Response to
Request for Additional Information No. 1, Revision 0
4/9/2008
U. S. EPR Standard Design Certification
AREVA NP Inc.
Docket No. 52-020
SRP Section: 6.2.1 – Containment Functional Design
Application Section: 6.2
SPCV Branch

Figure 6.2.1-07-1—Overhead View of Rupture and Convection Foils

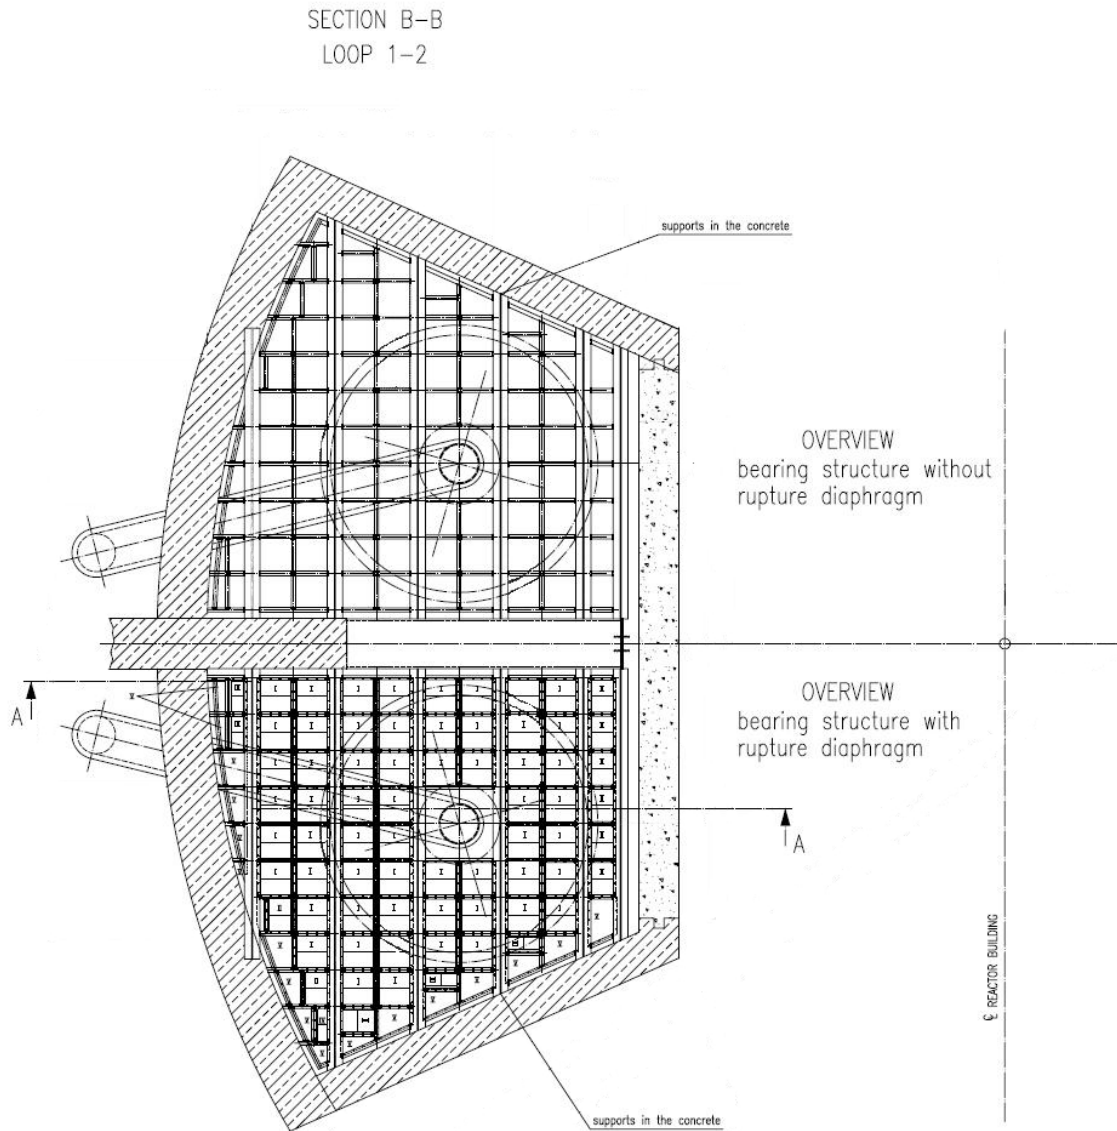
- a. Foils are installed in a steel framework. Does the framework separate the foil into many foils each of which has to rupture individually? What is the size of the individual foils? What is the total surface area of the foils? What is the available flow area once the foils rupture? Justify this flow area. What materials are the foils made of? What is the thickness of the foils? What is the weight of the foils per square foot? The above questions apply to both rupture foils and convection foils. In addition, how many fusible links are on the frame of a convection foil? Where are the links located?

The rupture and convection foils are installed in a steel framework above each steam generator and are separated into individual foils according to the layout provided in Figure 6.2.1-07-1. The types and sizes of the individual foils are listed in Table 6.2.1-07-1 including the flow areas.

Figure 6.2.1-07-3—Locations of Mixing Damper, Rupture Foils, and Convection Foils

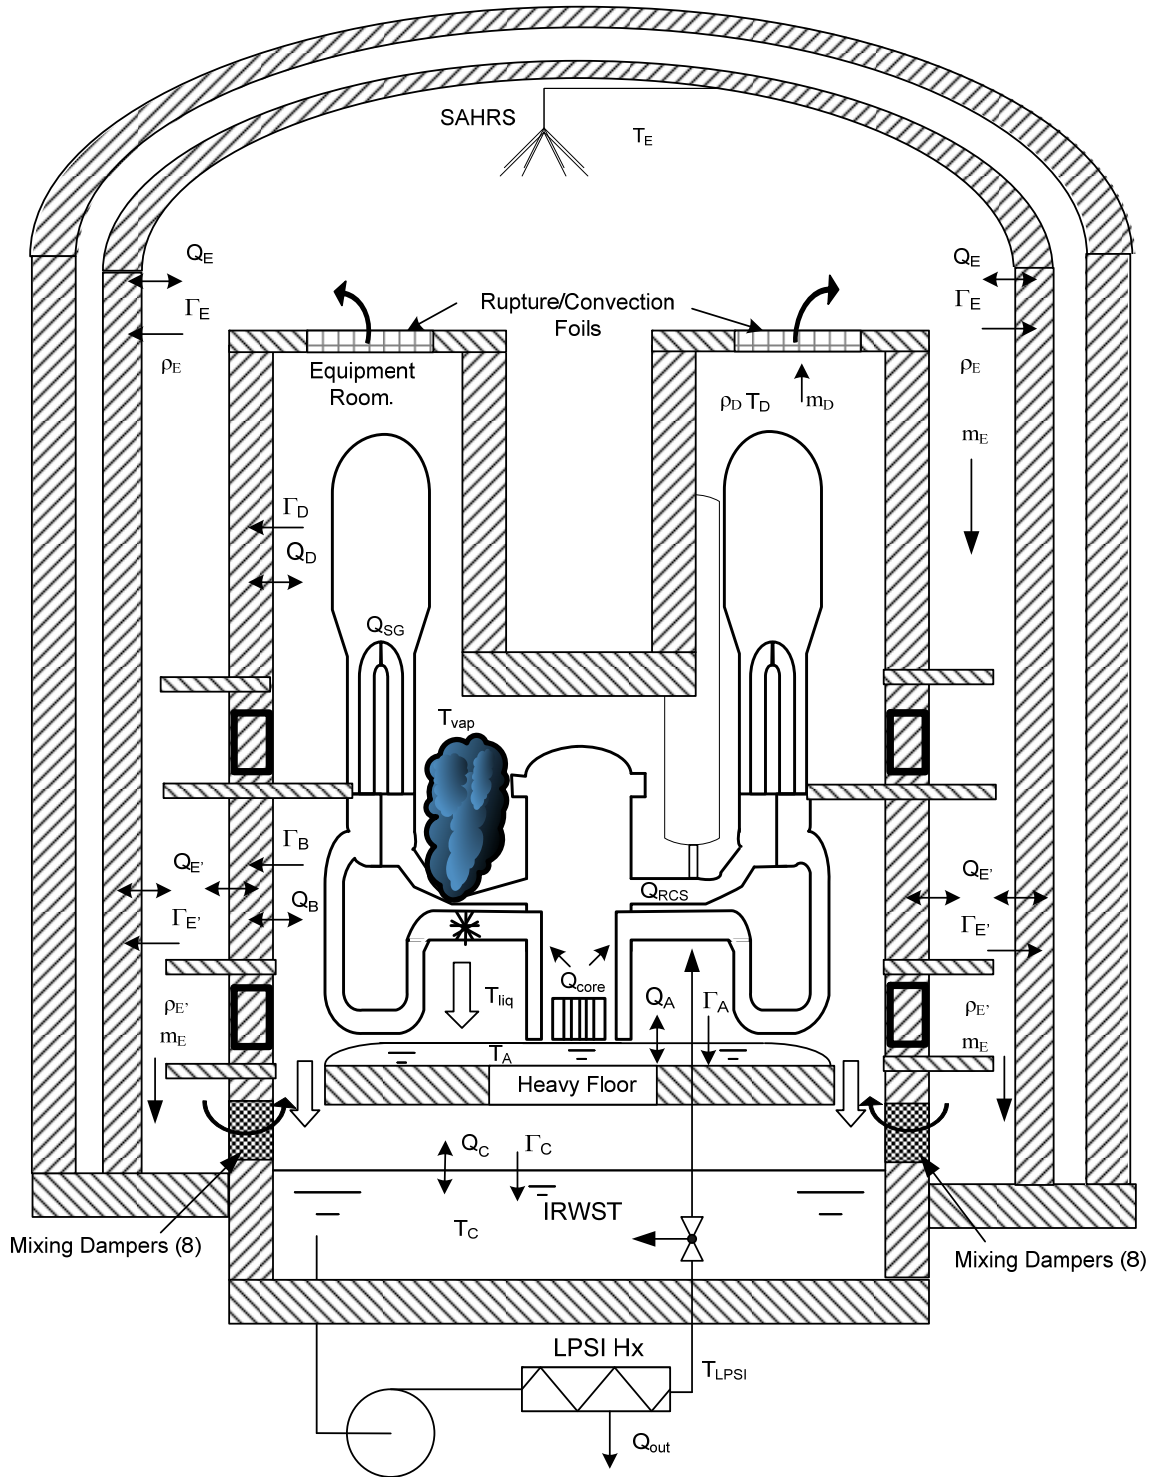
- b. Please provide a simplified sketch of the containment. Show internal walls, major components (steam generators, tanks, and so on) and the location and size of all mixing dampers, rupture foils and convection foils.

A simplified sketch of the containment is shown in Figure 6.2.1-07-3. The sketch shows the internal walls, major equipment, mixing damper locations, rupture foils, convection foils, and heat transfer parameters of interest.

The symbols in the sketch are defined as follows:

Q = heat transfer,
 Γ = condensation,
 ρ = density,
T = temperature, and
m = mass flow.

The subscripts in the sketch identify regions of the containment and are defined as follows:

A = heavy floor,
B = lower equipment room,
C = IRWST,
D = upper equipment room,
E = upper accessible area, and
E' = lower accessible area.

Figure 6.2.1-08-1—Comparison of Critical Flow Models at 2200 psia

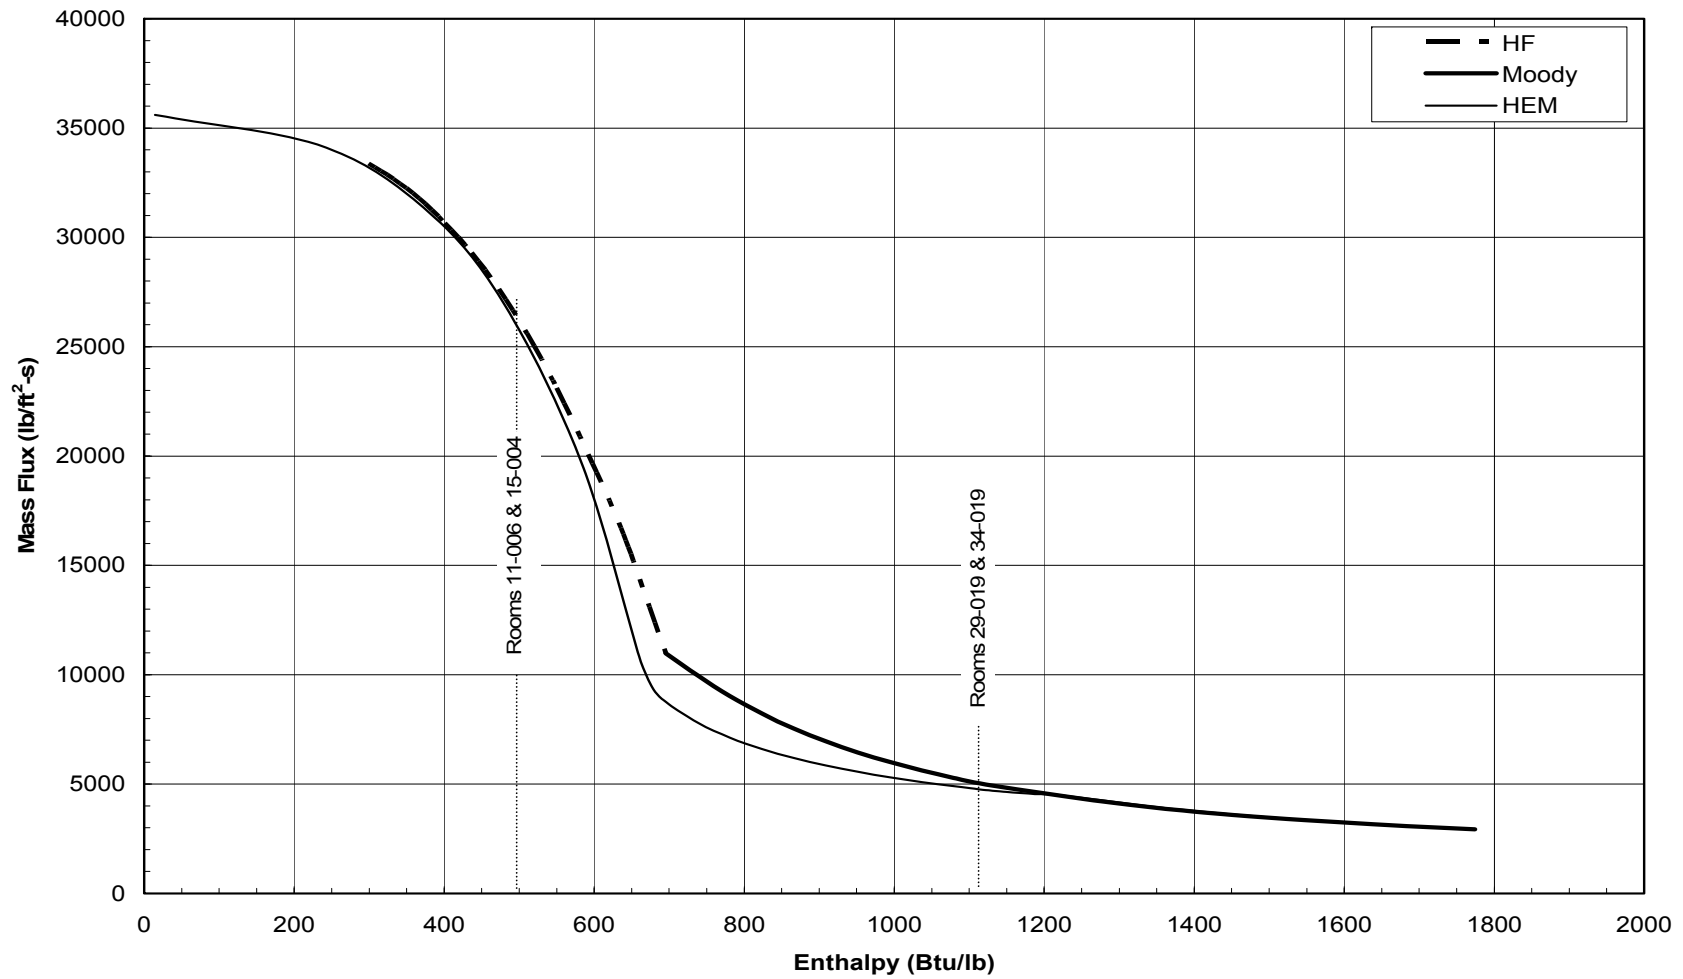
FSAR Section 6.2.1.2.3 states that the Homogeneous Equilibrium Model (HEM) is utilized in several of the cases to calculate the mass flux into subcompartments following a postulated piping break. The HEM is generally not acceptable for the calculation of liquid and two-phase critical flow from a piping break because it under predicts critical mass flow rates. Please provide subcompartment analyses using break flow models which are conservative for the prediction of critical flow.

The Moody and Henry Fauske critical flow models have tendencies to generally predict higher flow rates than the HEM. Figure 6.2.1-08-1 shows a comparison of predictions of HEM, Moody and Henry-Fauske models at 2200 psia as well as approximate conditions of two representative critical rooms. Figure 6.2.1-08-1 also shows that the difference between the critical flow models is most pronounced in the transition from subcooled to saturated conditions and gradually vanishes at either extreme (i.e., under highly subcooled water or superheated steam conditions). Unlike the Moody or Henry-Fauske models, the HEM covers the entire range of fluid states from subcooled water to superheated steam conditions. The tendency observed in Figure 6.2.1-08-1 is also observed at other pressures as illustrated in Figure 6.2.1-08-2, which shows a comparison of the critical flow models at 1200 psia.

Both the Moody and Henry-Fauske models are appropriate for determining the discharge of large vessels through short nozzles or orifices where slip and phase non-equilibrium effects come into play. For discharges through long pipes, the HEM offers a more realistic approach because with increasing travel distance, flow approaches homogeneous equilibrium conditions. This is confirmed in an EPRI study of critical flow models which concludes that for $L/D > 1.5$, HEM produces good agreement with test data [Ref. 1]. Similarly, in a topical book co-authored by F. J. Moody, it is stated that, "The Moody model predicts equilibrium flowrates somewhat higher than data representative of [boiling water reactor] BWR blowdowns..." The author further states that the homogeneous equilibrium model agrees quite well with the available data [Ref. 2]. This confirmation applies to pressurized water reactors because BWR conditions also exist in pressurized water reactor systems.

Figure 6.2.1-09-1—Comparison of Containment Pressure Histories for Case Identified in FSAR Figure 15.6-50

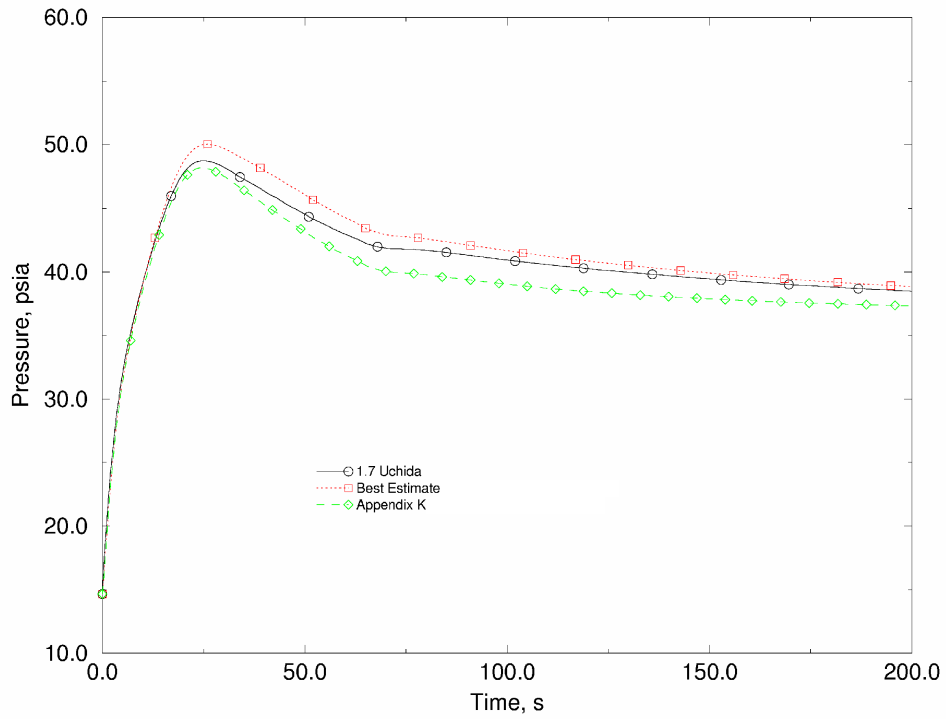
- b. Describe and justify assumptions made for the mixing between containment steam and the spilled ECCS water.
- c. FSAR Section 15.6.5.1.2 indicates that a condensing heat transfer coefficient of 1.7 times that predicted by the Uchida correlation is used. Provide a comparison of the containment pressure result during the core reflood period between this assumption and that produced by the heat transfer model recommended in BTP 6.2 which is 4 times the Tagami correlation followed by 1.2 times the Uchida correlation. Provide this justification specifically for the US-EPR analysis given in Figure 15.6-50.

The realistic large-break LOCA (RLBLOCA) methodology described in the Topical Report, ANP-10278P, "U.S. EPR Realistic Large Break Loss of Coolant Accident Topical Report," incorporates a best estimate containment pressure calculation based on heat transfer coefficients of 1.0 times Tagami and 1.2 times Uchida. Because the ICECON containment pressure calculation is performed concurrent with the S-RELAP5 blowdown calculation, it is not possible to use Tagami directly. The Tagami correlation requires advance knowledge of total

energy transferred to the containment during blowdown and the time of end of blowdown. Figure 3-1 of ANP-10278P shows the process by which AREVA NP Inc. validates that the use of the Uchida correlation alone with a multiplier of 1.7 produces a pressure response that conservatively bounds the best estimate Tagami-Uchida formulation (1.0 times Tagami and 1.2 times Uchida).

Figure 6.2.1-09.1 compares these containment pressure responses for the case requested (FSAR Figure 15.6-50).

Figure 6.2.1-09.1 includes the corresponding pressure response calculated using 10 CFR 50, Appendix K rules (i.e., 4.0 times Tagami and 1.2 times Uchida).

Figure 6.2.1-10-1—Short Term Annulus Sub-Pressure Response, Limiting Case

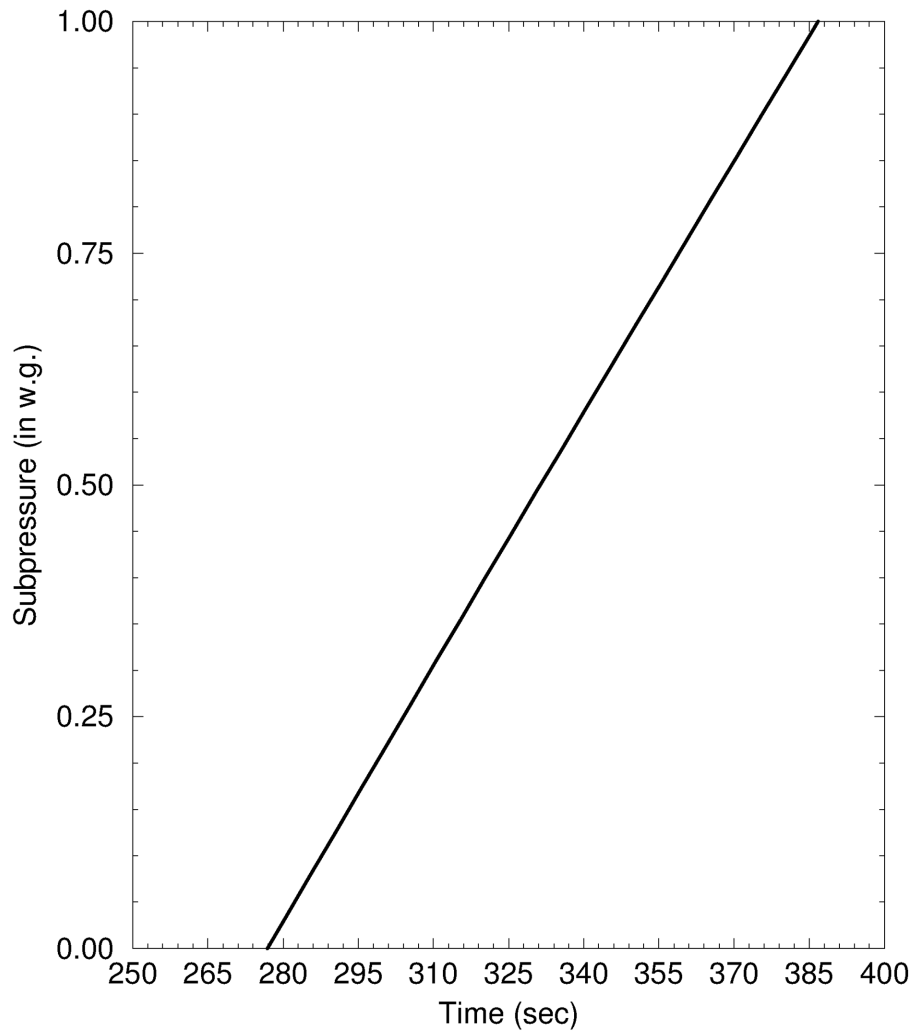
FSAR Section 6.2.3 describes the US-EPR Reactor Shield Building (RSB). Provide the evaluation for the RSB post LOCA pressure and temperature following design basis conditions. Provide the graphical results for the limiting case of the atmospheric pressure and temperature and the reactor containment building (RCB) wall temperature. The evaluation should include heat transfer from the RCB, the equipment heat loads within the RSB and the decrease in the RSB volume as the result of thermal and mechanical expansion of the RCB.

An evaluation was performed to determine the thermal hydraulic response of the annulus between the RSB and the RCB following a design basis LOCA. This analysis is discussed in FSAR Section 6.2.3.3 and Table 6.2.3-2. Specifically, the analysis takes into account heat transfer from the RCB by conservatively assuming an infinite heat transfer coefficient. The concrete wall of the RCB is ≈ 3 feet thick; therefore, the actual RCB conditions and heat transfer from the RCB are unimportant in this evaluation. During a postulated LOCA, heat loads generated within the annulus are negligible; therefore, there is no need to account for them in the evaluation. The decrease in the annulus volume because of thermal and mechanical expansion of the RCB is conservatively modeled by step-reducing the annulus volume at the start of the event.

Figures 6.2.1-10-1 through 6.2.1-10-4 present the annulus pressure and temperature and RCB wall temperature for the limiting case. The analysis covers the first 24 hours after the postulated accident. Figure 6.2.1-10-1 shows the short term response of the annulus pressure at the lowest containment elevation. The annulus pressure initially increases before the annulus ventilation system (AVS) is activated, 60 seconds after the start of the postulated accident, and gradually decreases after the AVS is activated. The results indicate that the AVS draws down the annulus to -0.25 inches water gauge in 305 seconds and to -2.5 inches water gauge in 565 seconds. The long term annulus pressure response, shown in Figure 6.2.1-10-2, demonstrates the capability of the AVS to maintain the annulus at design subatmospheric conditions.
